PRAIRIE ISLAND INDIAN COMMUNITY  
LEGAL DEPARTMENT

Re: Comments on the final EIS for PUC Docket E002/CN-08-509 (Extended Power Uprate) and PUC Docket E002/GS-08-690 (Site Permit Application)

*PINGP Tracer Modeling for  
Sturgeon Lake*

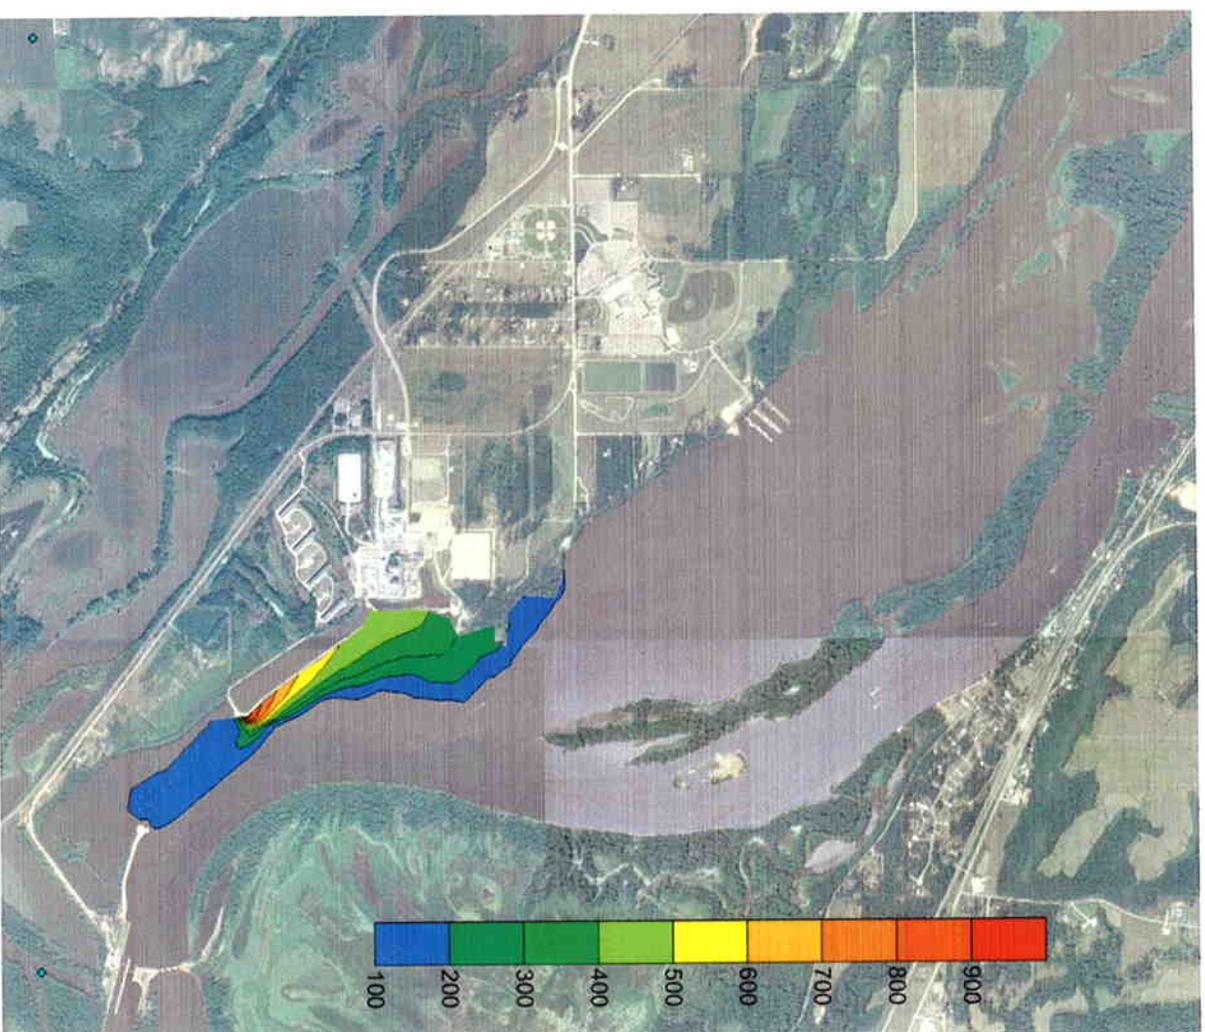
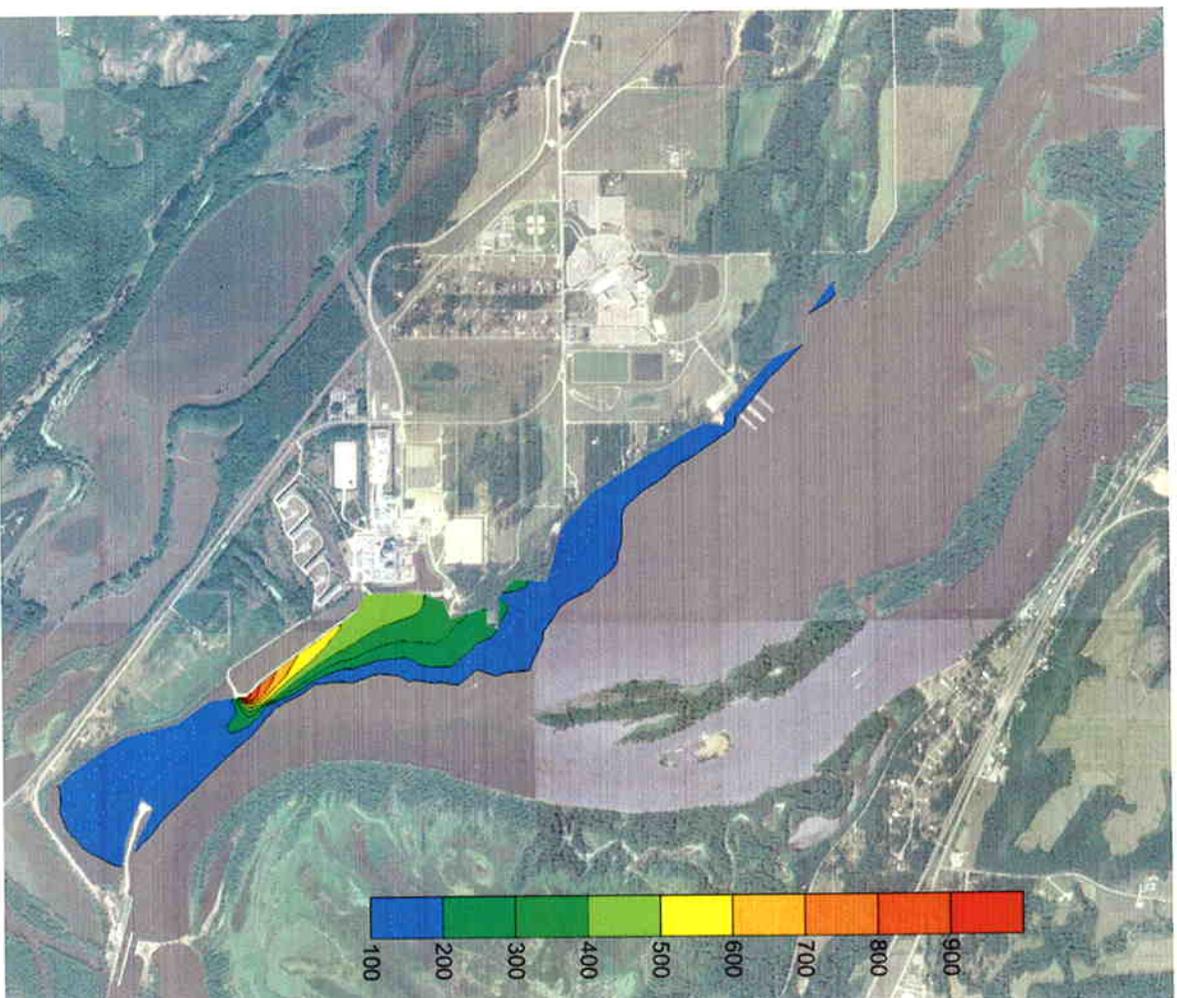
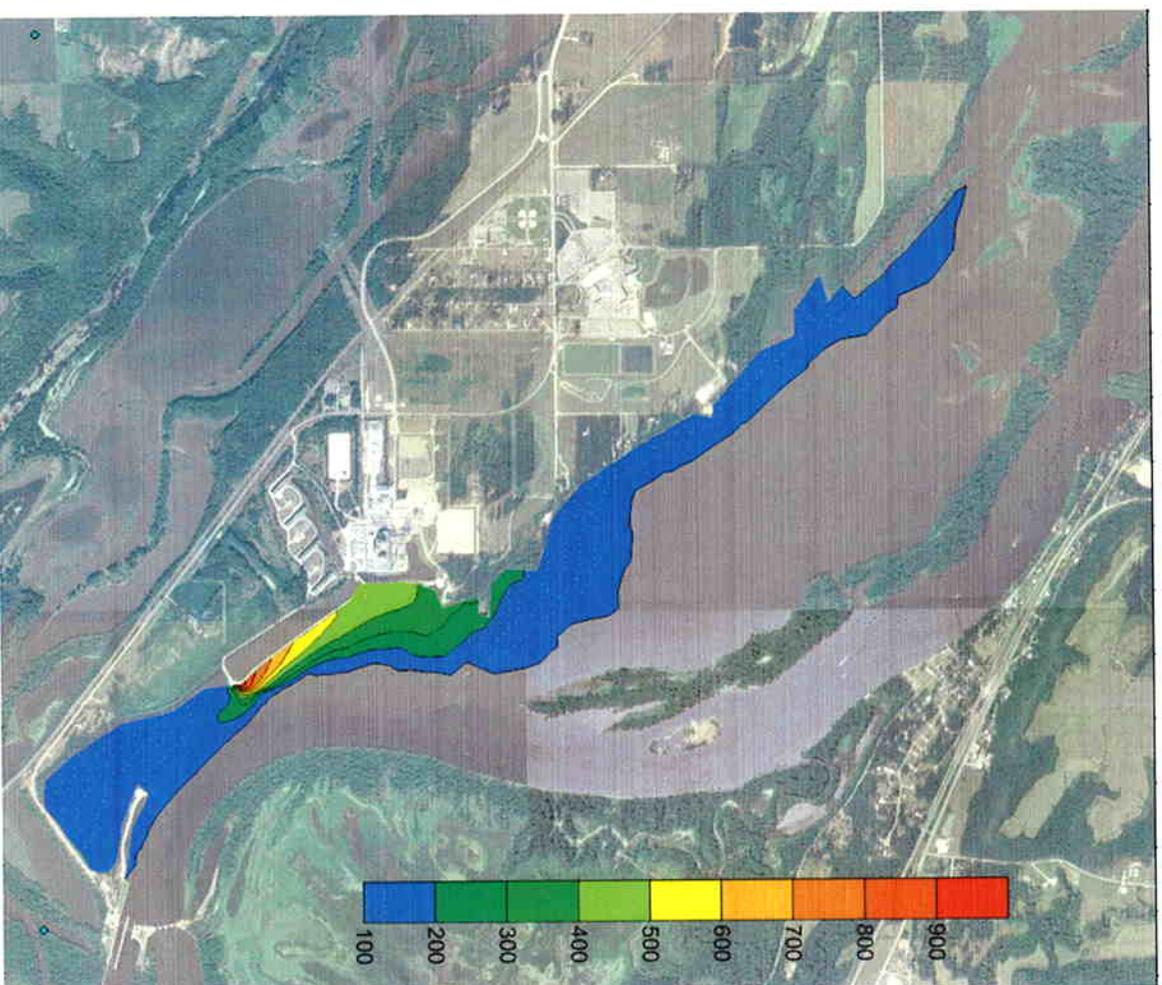
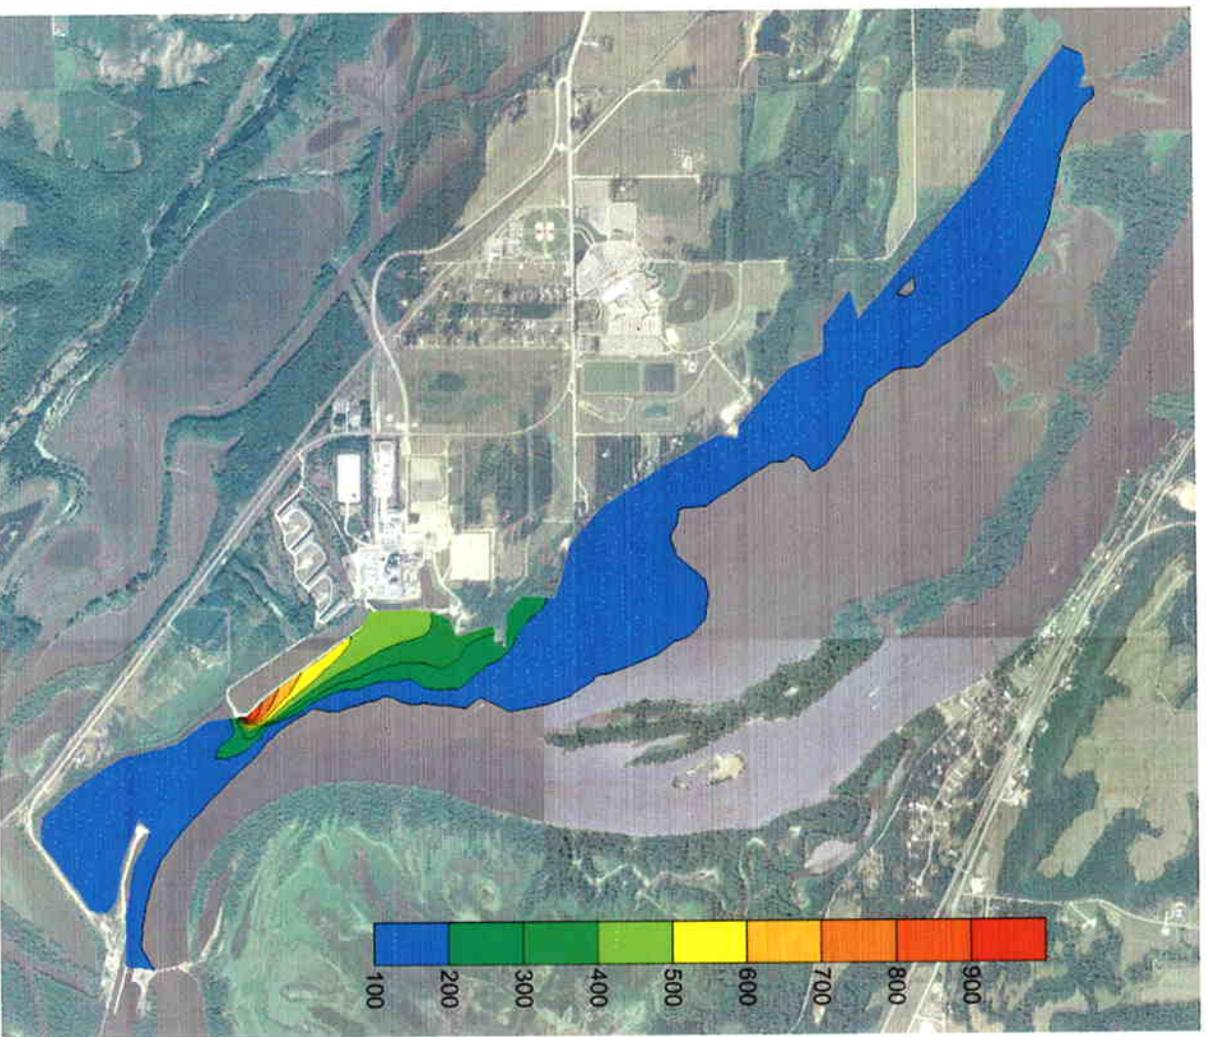
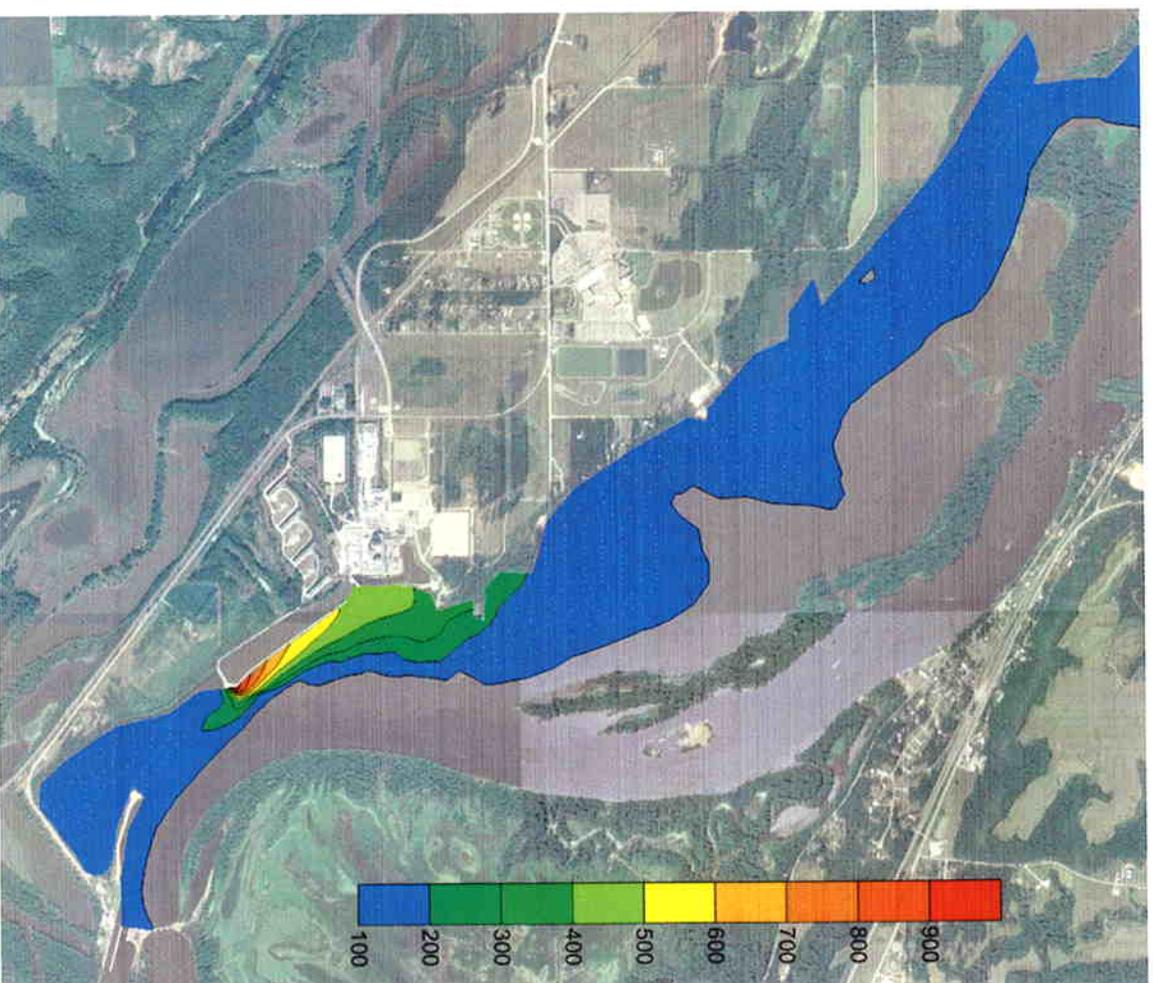
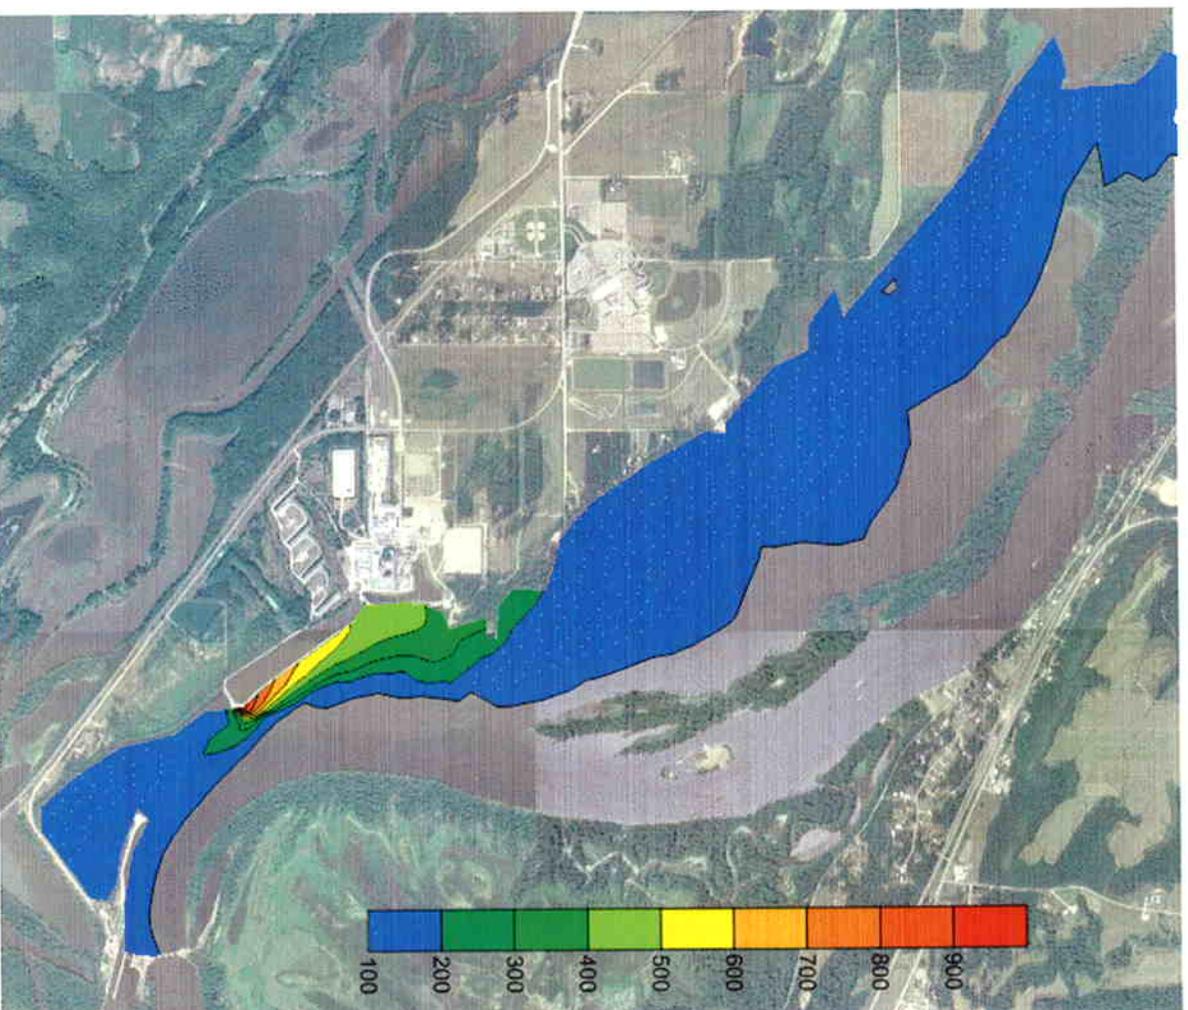
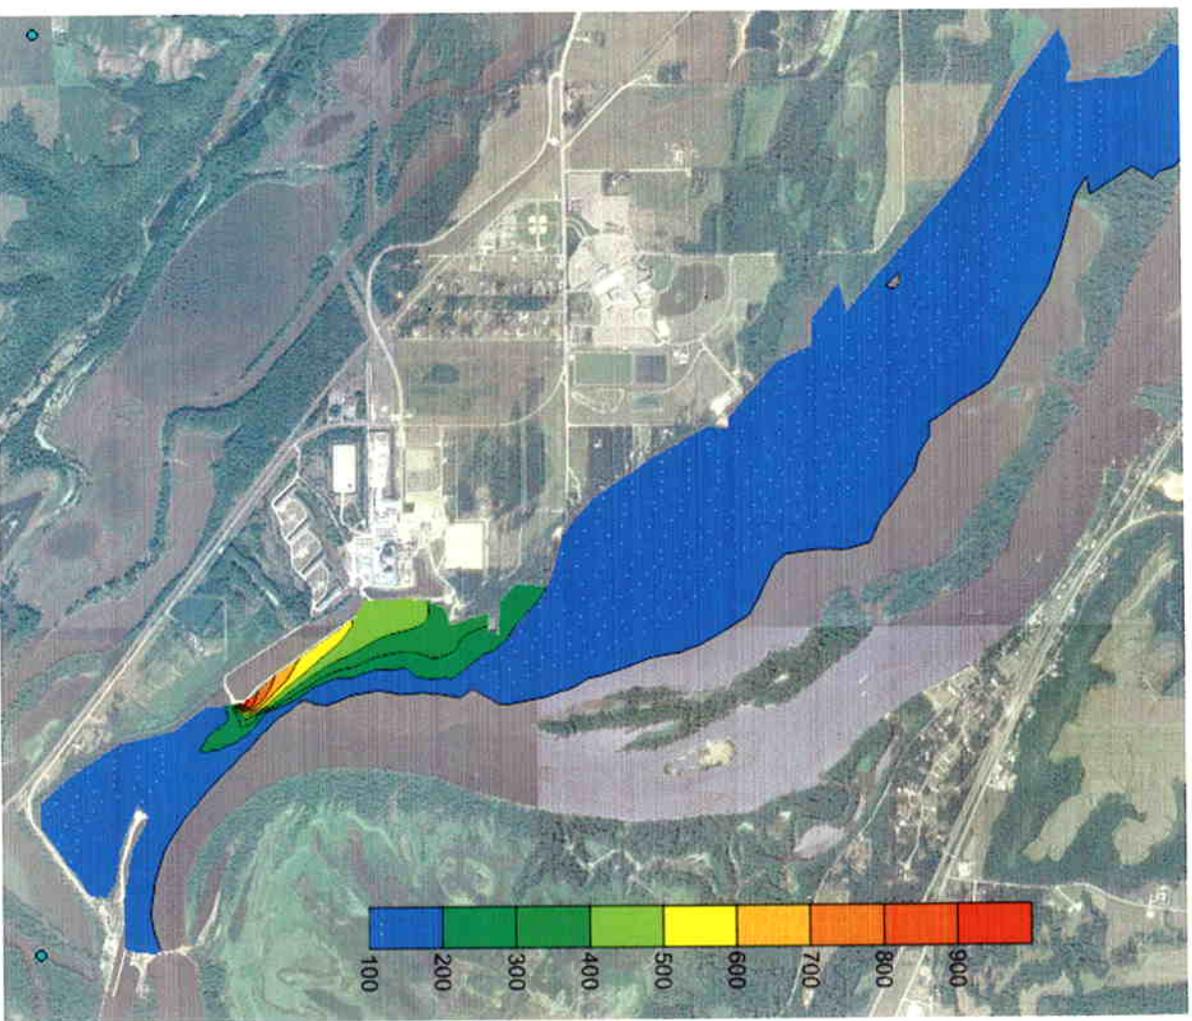
Another Study H.G. Stefan also demonstrated that the surface waters of the river actually flow back upstream (back to Sturgeon Lake) when winds are out of the S, SE, SW, E or W (varying with the speed of the wind). As we noted in our draft EIS comments, this would certainly impact not only the thermal pollution -- instead of distributing and discharging downstream, it would be pushed back upstream, potentially impacting aquatic species, like the federally-listed Higgins eye mussel. This could also potentially affect the radiological effluents from the PINGP as well.

We support the DNR's recommendation that, as a condition of the site permit, Xcel Energy be required to initiate a study that would update the Stefan studies, including an analysis of impacts to Sturgeon Lake, and that Xcel be required to expand its cooling tower capacity. Based on the Community's own preliminary analysis, the potential for adverse impacts upstream remain very real – and as of yet unaddressed – in the FEIS. See Exhibit 1.
